Parramatta North Urban
Transformation
Draft State Environmental Planning Policy
(PNUT) 2014

Response to
Submissions

9 June 2015

Figure 1: Revised ILP for Parramatta North Urban Transformation area

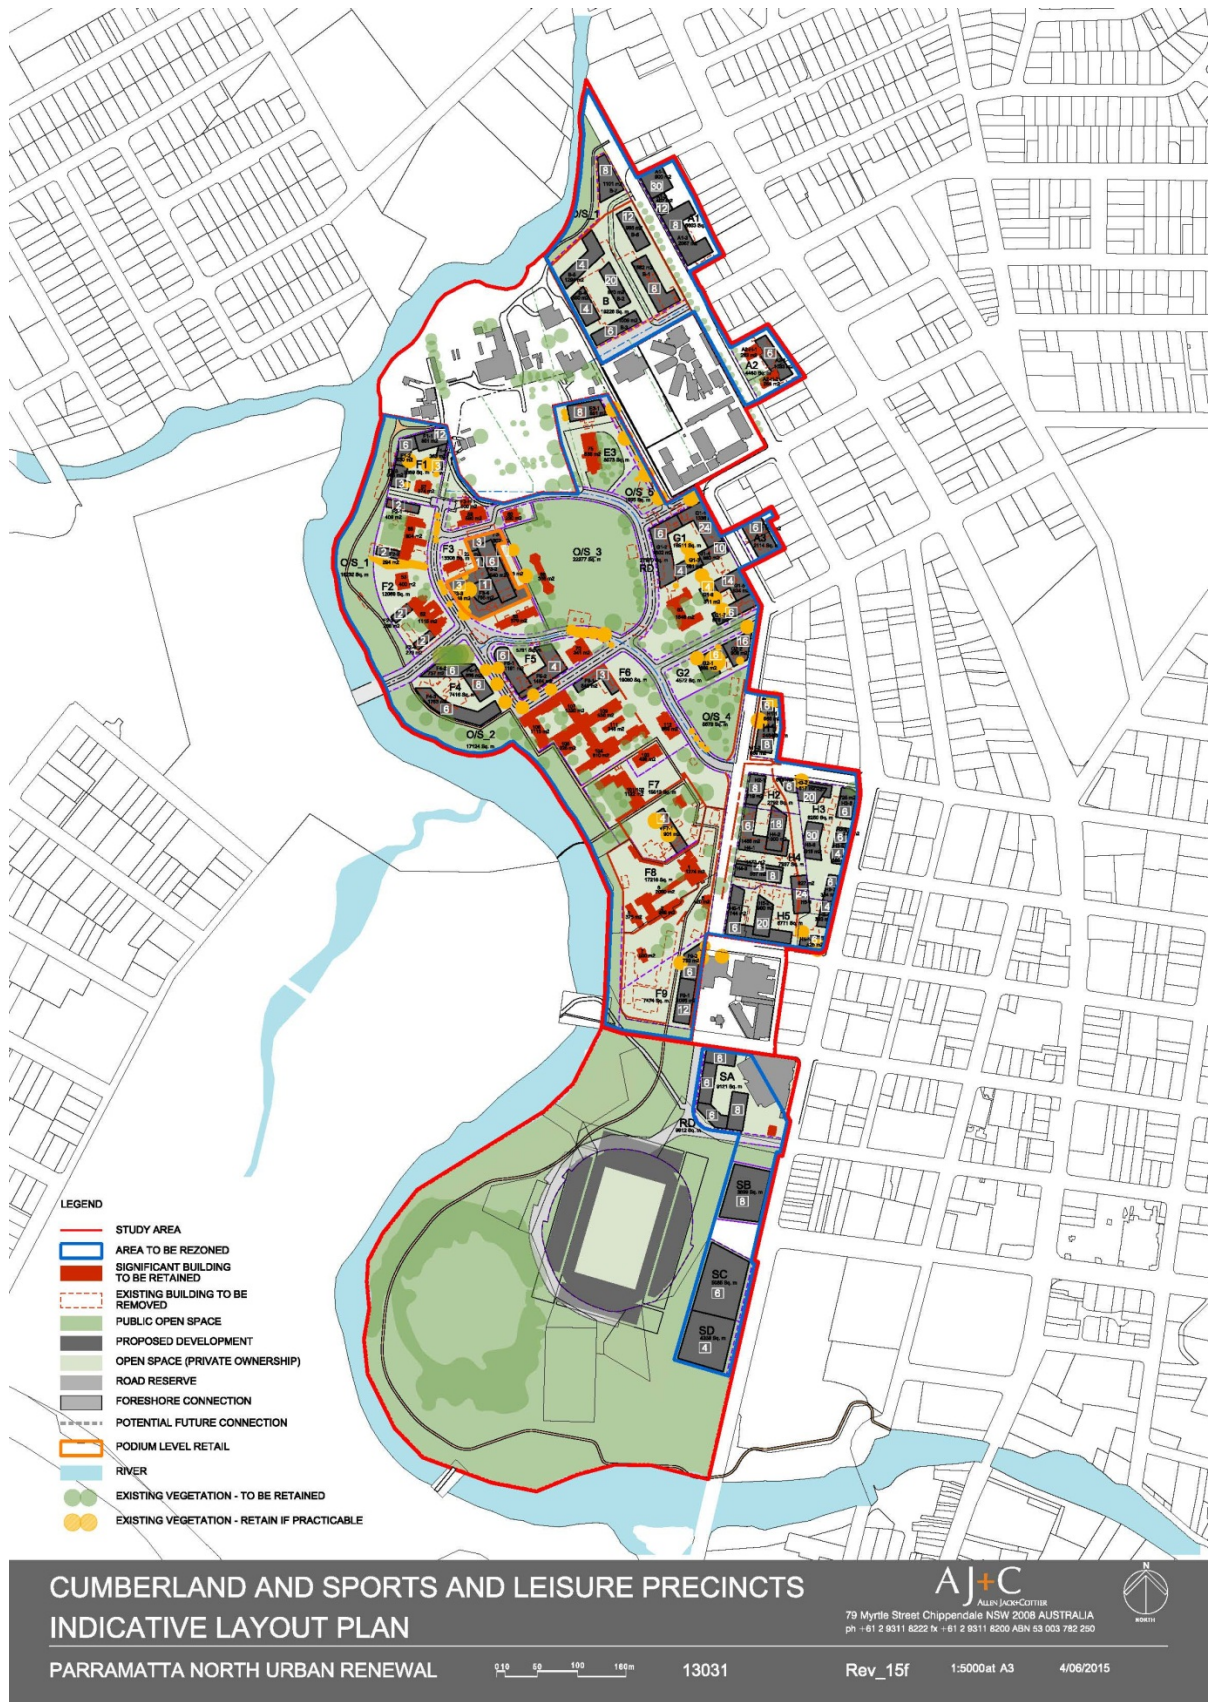
- Remove proposed building F7-1 and reduce building F7-2 from 6 storeys to 4 storeys reducing the amount of potential development and building heights near the Female Factory Precinct F6 (this building is now marked as F7-1 on the plan).

- The revisions have reduced the overall gross floor area (GFA) by 13,366m². The total GFA proposed is now 420,088m² reduced from 433,454m².
- Remove the part 6 and part 16 storey building from Precinct E3 and convert the now vacant area to open space (O/S5);

Precinct	Proposed Revisions
A1	<ul style="list-style-type: none"> • Proposed 30 storey building footprint revised to be a part 30 and part 12 storey building • The proposed 4 storey wing (A1-1) has been removed • Former 4 storey building (A1-4) has been increased to 8 storeys centrally in the block and combined with building A1-3
A2	<ul style="list-style-type: none"> • No changes
A3	<ul style="list-style-type: none"> • No changes
B	<ul style="list-style-type: none"> • The northern 12 storey building footprint (B-6) relocated to provide a

Precinct	Proposed Revisions
	<ul style="list-style-type: none"> Proposed 6 storey building fronting O'Connell Street increased to 10 storeys 10 storey building increased to 14 storeys 4 storey building increased to 6 storeys and building form broken to provide U-shape building footprint The building form along New Street broken to provide a western view corridor to building No.83
G2	<ul style="list-style-type: none"> G2-1 height remains unchanged. Building footprint modified and slightly increased to create a courtyard configuration Building G2-2 increased from 14 to 16 storeys Amended building footprint results in no change to the open space area of O/S_4.
H1	<ul style="list-style-type: none"> No changes
H2	<ul style="list-style-type: none"> The full perimeter building form for precincts H2-H5 has been replaced with building separation to the street network to mitigate the dominance of the built form H2 now proposes an 8 storey building (H2-1) and a 6 storey building (H2-2), instead of the single 8 storey building

O/S5	<ul style="list-style-type: none"> New Open space area O/S5 provided of 1,595m² to provide additional open space to be dedicated to Parramatta City Council.

The amended ILP Revision 15f is provided in Figure 1.

PROPOSED LAND ZONING

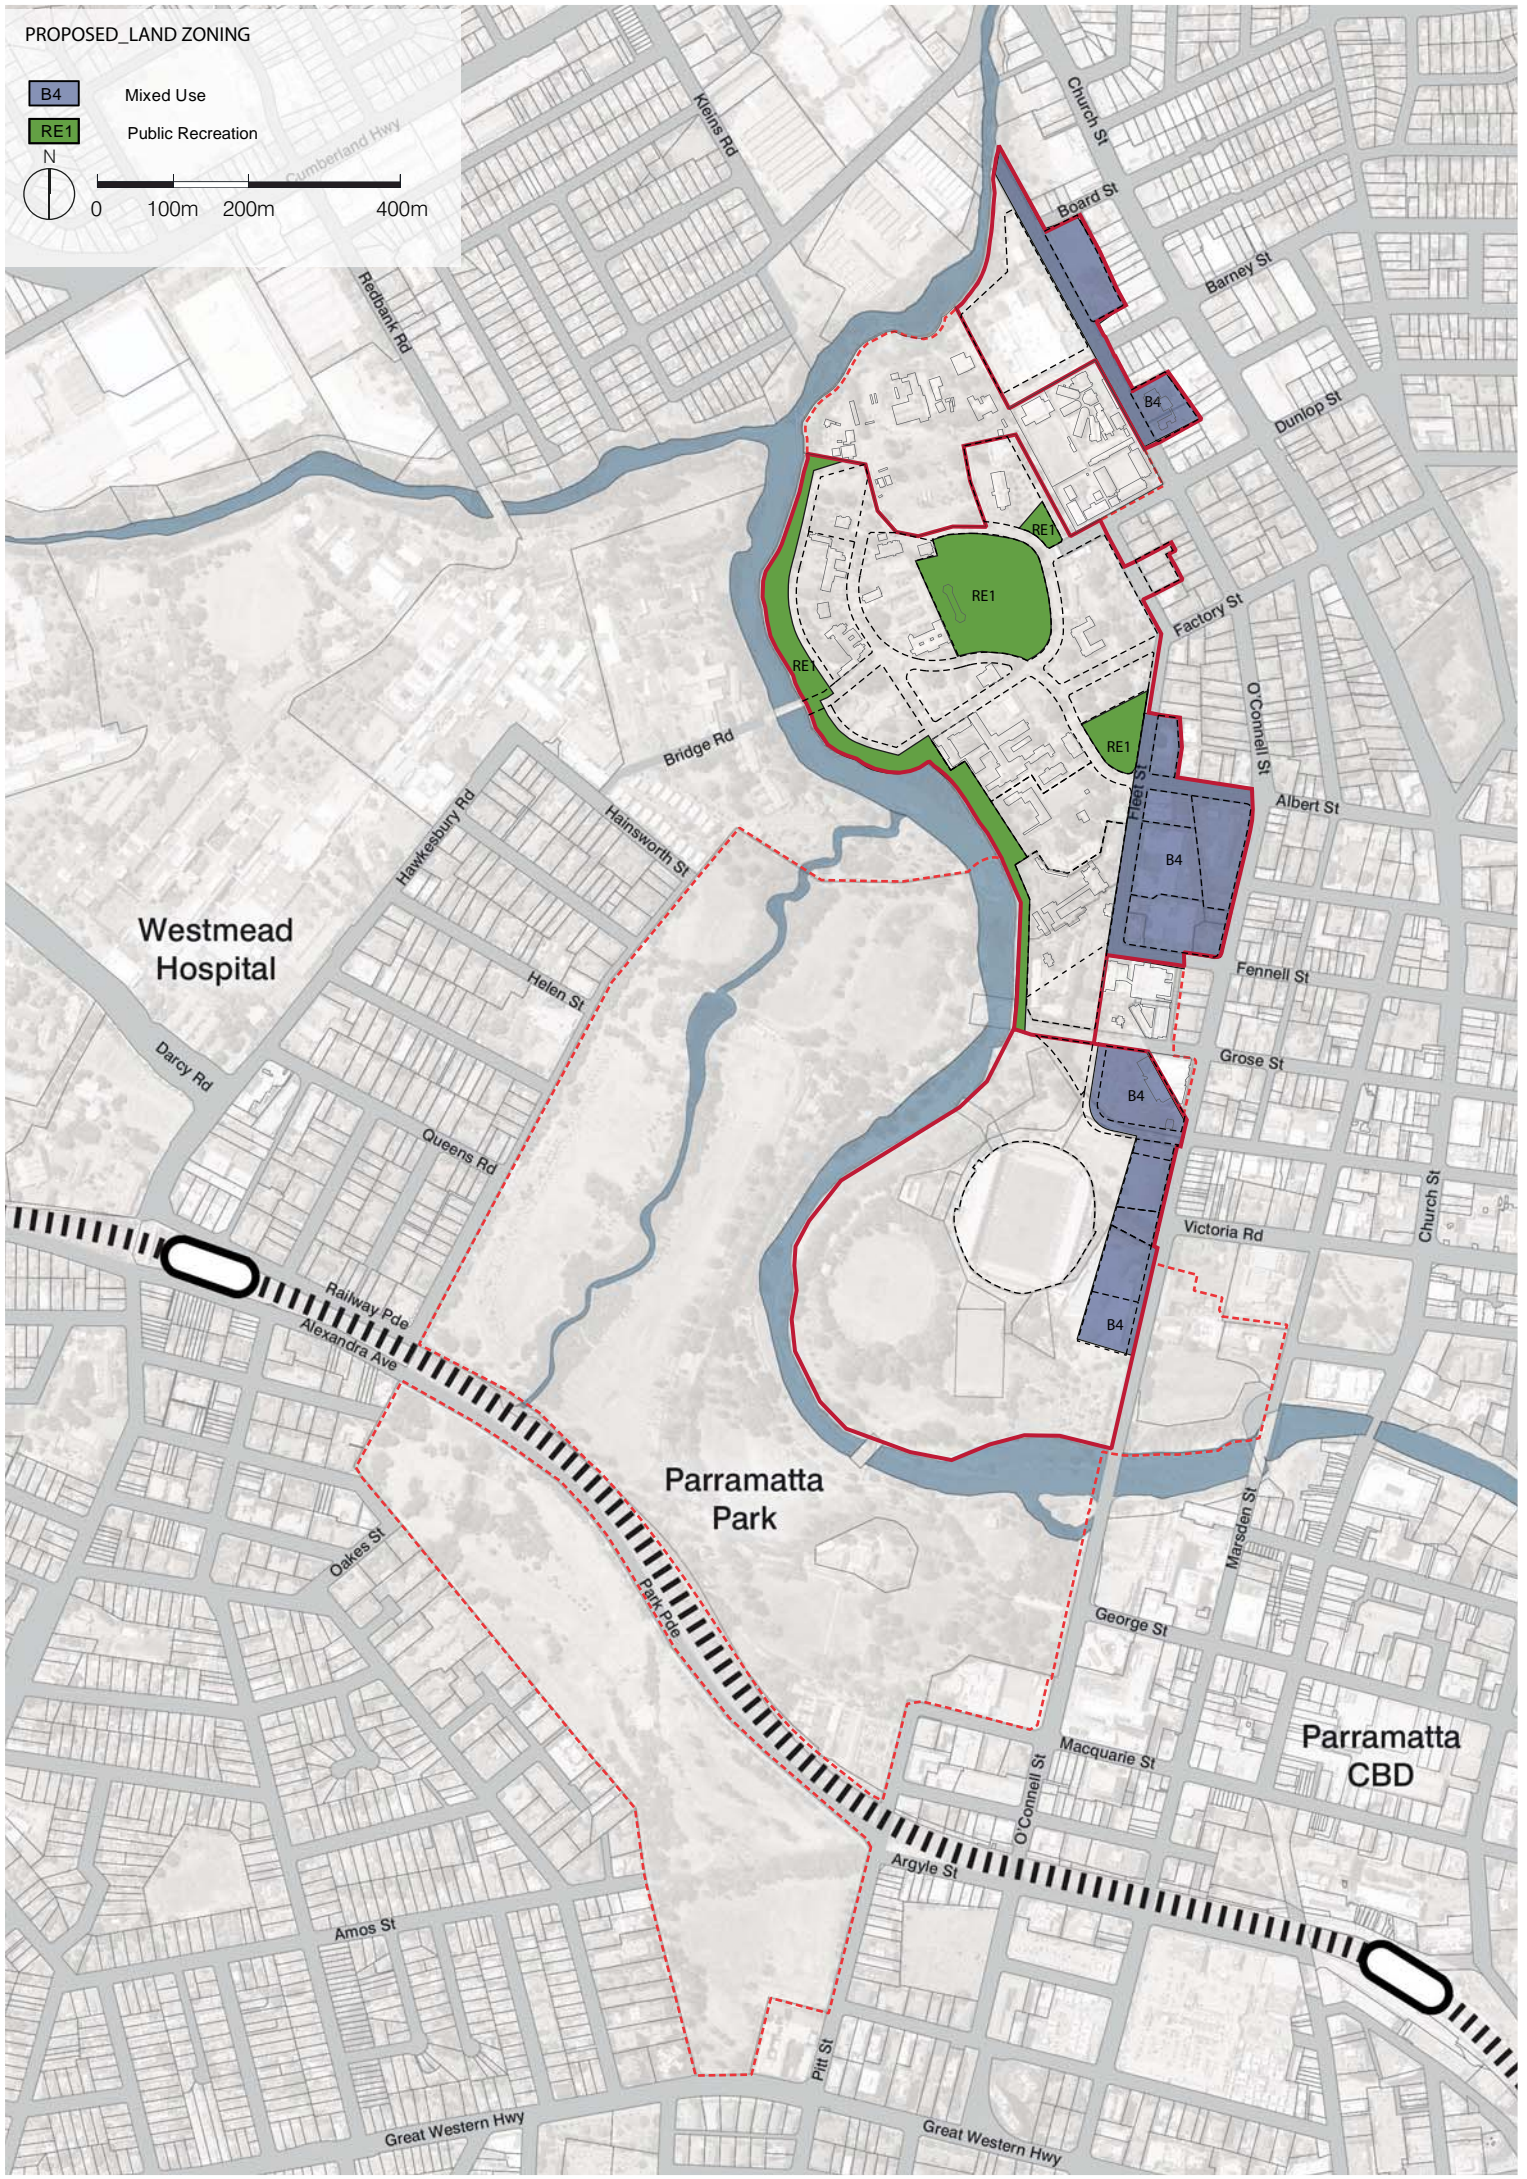
The revised Land Zoning map nominates O/S1, O/S2, O/S3, O/S4 and O/S5 as RE1 Public Recreation instead of RE2 Private Recreation. This land is currently zoned B4 Mixed Use. The dedication of these areas to Parramatta City Council will ensure their long-term maintenance and management for community benefit and responds to concerns raised over their future management. The nomination of these areas as public open space zoned RE1 Public Recreation is consistent with the submission to the project prepared by Parramatta City Council.

Consequential amendments to the draft Land Zoning map and Height of Buildings map have been made and reflected the ILP revision. These amended draft LEP plans are included at Attachment 2.

PROPOSED_MAXIMUM FSR

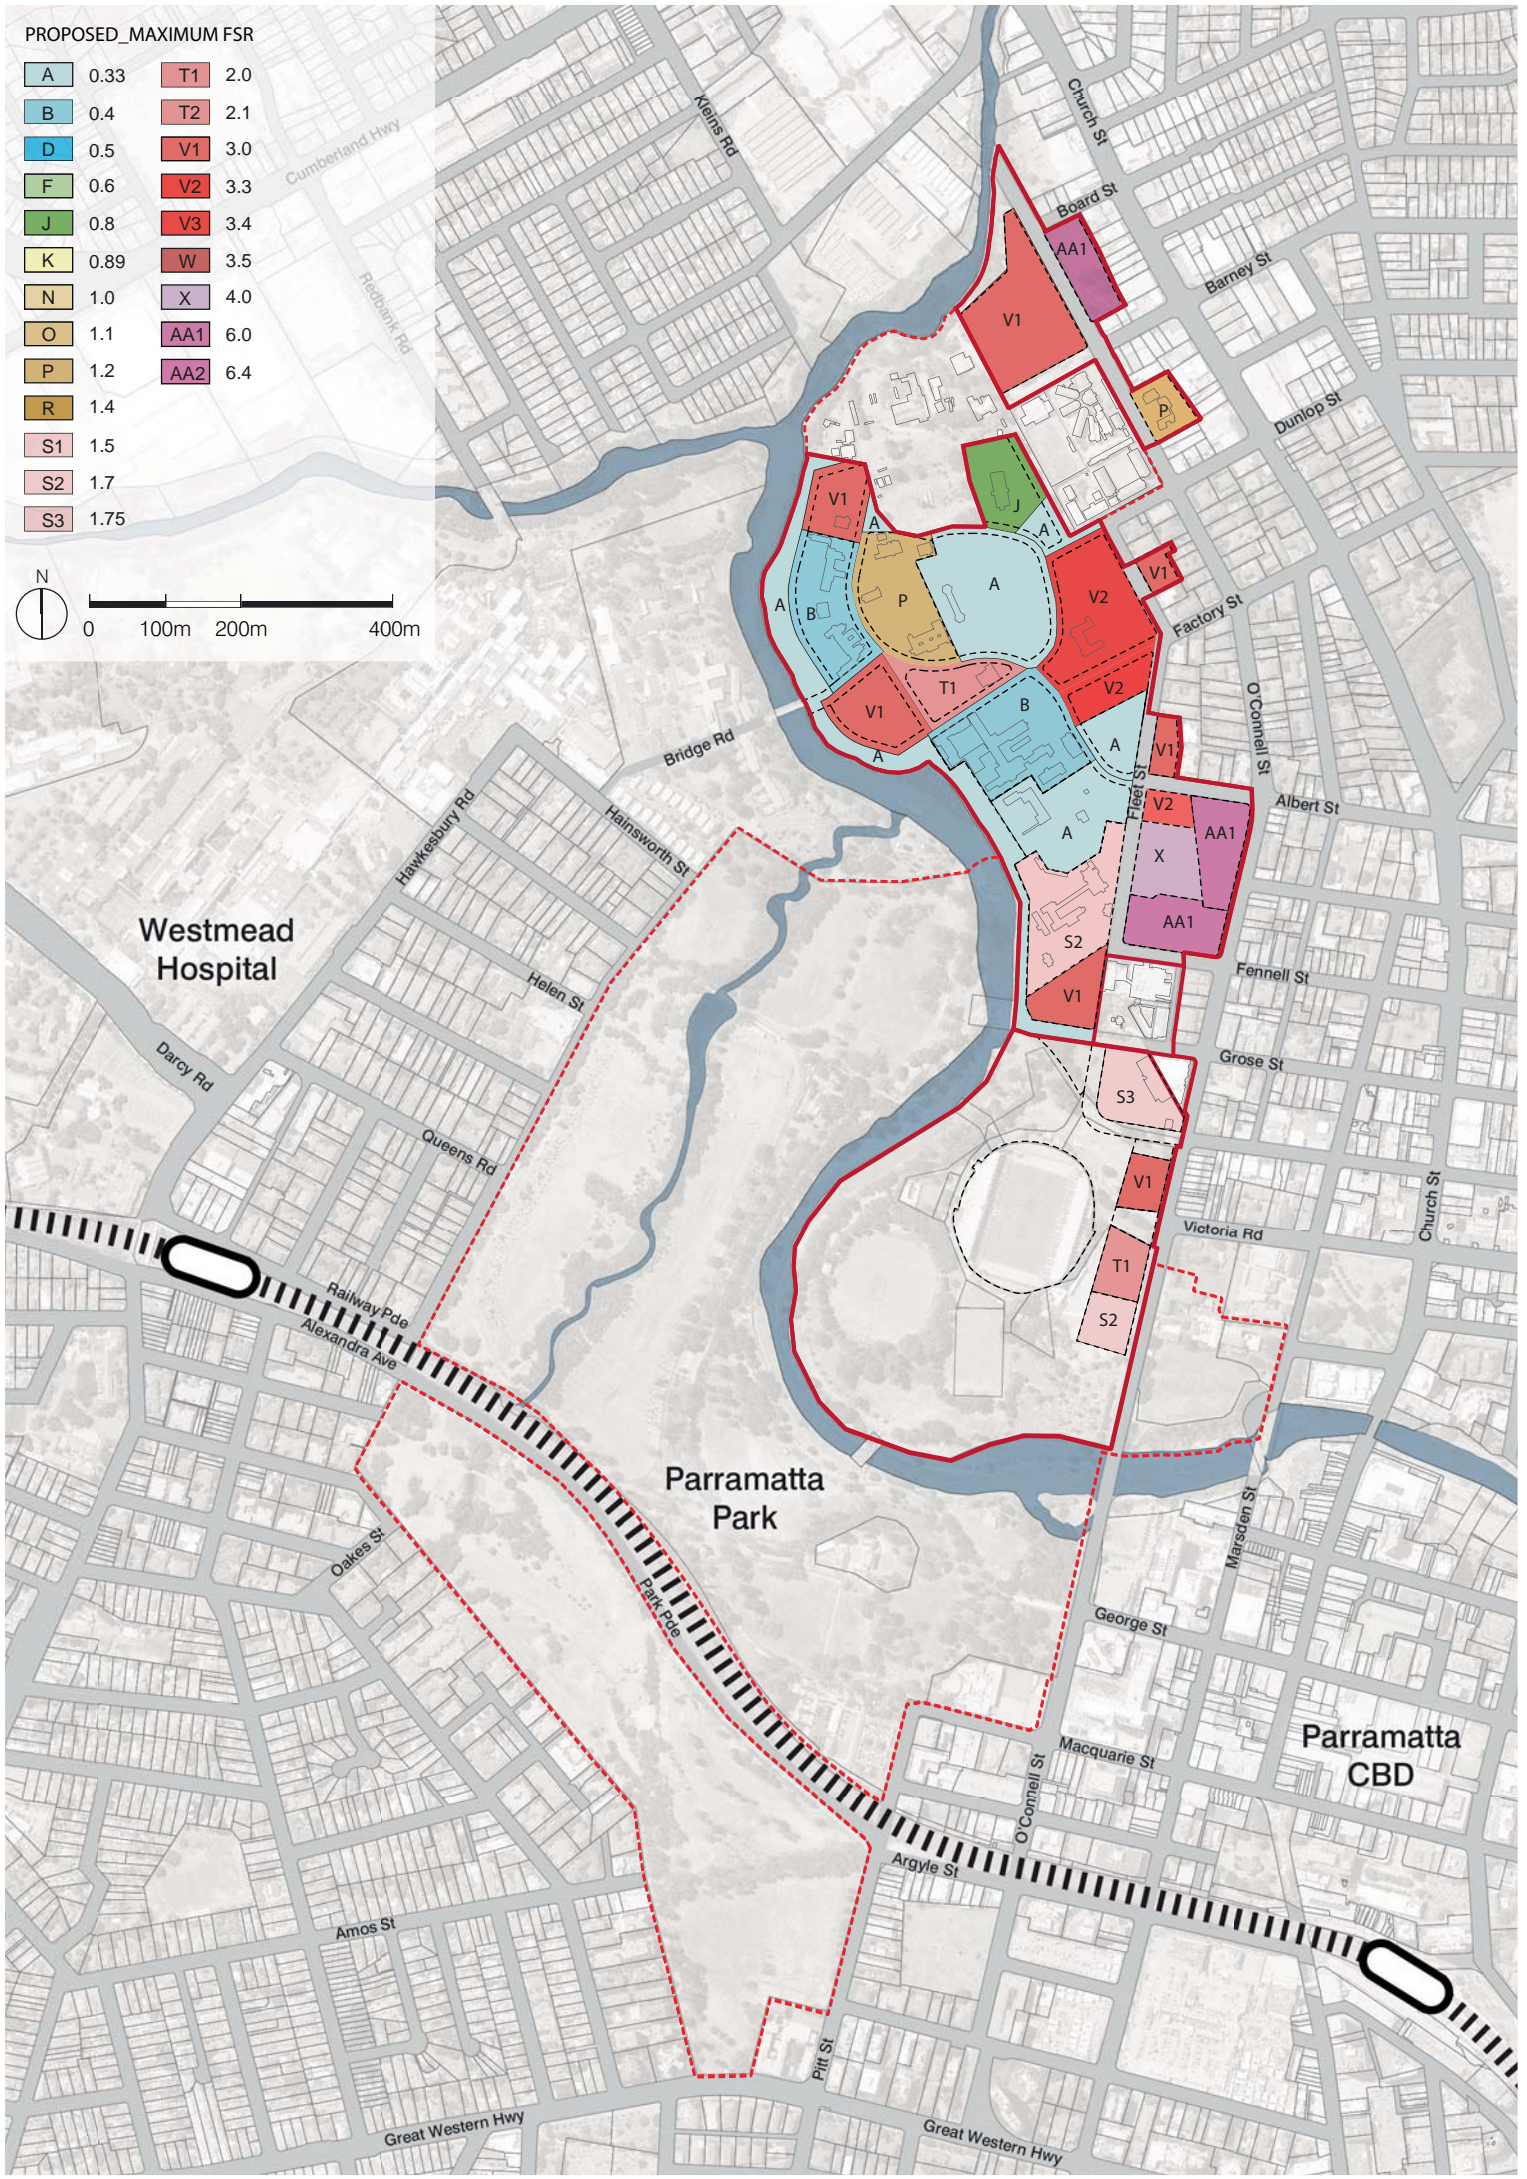
The proposed Gross Building Area control has been replaced with an FSR map in response to feedback and to provide consistency with the Standard Instrument LEP.

A FSR development standard map replaces the originally proposed Gross Building Area map for each precinct. The proposed FSR map is included at Attachment 2. Table 1 compares the effective FSR proposed in the exhibited study and the revised ILP.
